Access Compliance Report

Public Rights-of-Way

(Curb Ramps)

Intersection ID: 30295	Main Street: CABOT_HILL_CT	Cross Street: HAMPTON_WAY_DR	Location: SW
ADA ID: 66673FB688FB	Ramp Type: BlendTrans1	Initial Pass/Fail: Fail	Overall Compliance: No
Severity Score: 10			
Codes/Mitigation Info/Possible Solution		Field Measurements/Component Compliance

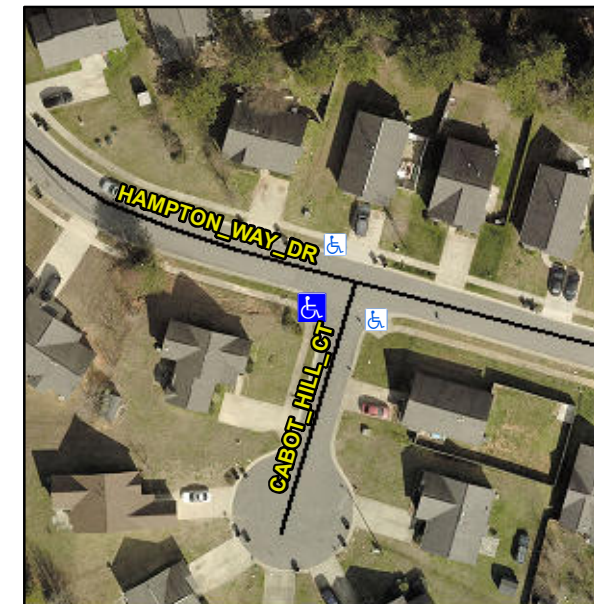
DAMAGED CURB/GTR

Not Found, R304.5.1, R304.5.3

Compliance	Description	Data	Compliance	Description	Data
N/A	Ramp Length (in)	48.0	Yes	BlendTrans Slope (%)	4.9
No	Ramp Width (in)	41.0	No	BlendTrans XSlope (%)	2.5
N/A	Flare Type LT	N/A	N/A	Flare Type RT	N/A
N/A	Flare Slope LT (%)	N/A	N/A	Flare Slope RT (%)	N/A
N/A	Flare Traversable LT?	N/A	N/A	Flare Traversable RT?	N/A
N/A	Landing Length (in)	N/A	N/A	DWS Provided?	N/A
N/A	Landing Width (in)	N/A	N/A	DWS Contrast?	N/A
N/A	Landing Slope (%)	N/A	N/A	DWS Length (in)	N/A
N/A	Landing X Slope (%)	N/A	N/A	DWS Full Width?	N/A
N/A	Landing Curb? (Y/N)	N/A	N/A	DWS Offset (in)	N/A
N/A	Shared Landing?	N/A			
N/A	Gutter Ponding?	N/A	N/A	Gutter Slope (%)	N/A
N/A	Gutter Lip Ht (in)	N/A	N/A	Gutter X Slope (%)	N/A
N/A	Painted X Walk1?	No	N/A	Painted X Walk2?	No
	X Walk 1 Direction	To E		X Walk 2 Direction	To N
	X Walk 1 Width (in)	N/A		X Walk 2 Width (in)	N/A
	X Walk 1 Slope (%)	5.0		X Walk 2 Slope (%)	0.9
	X Walk 1 X Slope (%)	1.7		X Walk 2 X Slope (%)	3.3

N/A	Ramp inside XWalk1?	N/A	N/A	Ramp inside XWalk2?	N/A
	Road Slope (%)	3.3		Clear Space?	N/A
	Road X Slope (%)	2.4	N/A	Clear Space to XWalk (in)	N/A
N/A	Any Obstructions?	N/A	N/A	Storm Grate/Utility Hazard?	N/A
	Obstruction Type			Storm Grate/Utility Type	
		N/A			N/A
			Yes	Surface Condition? (G/P)	Good
			No	Curb Slope (%)	26.6

Remove & Replace Curb Ramp With Two New Directional Ramps or Equivalent.
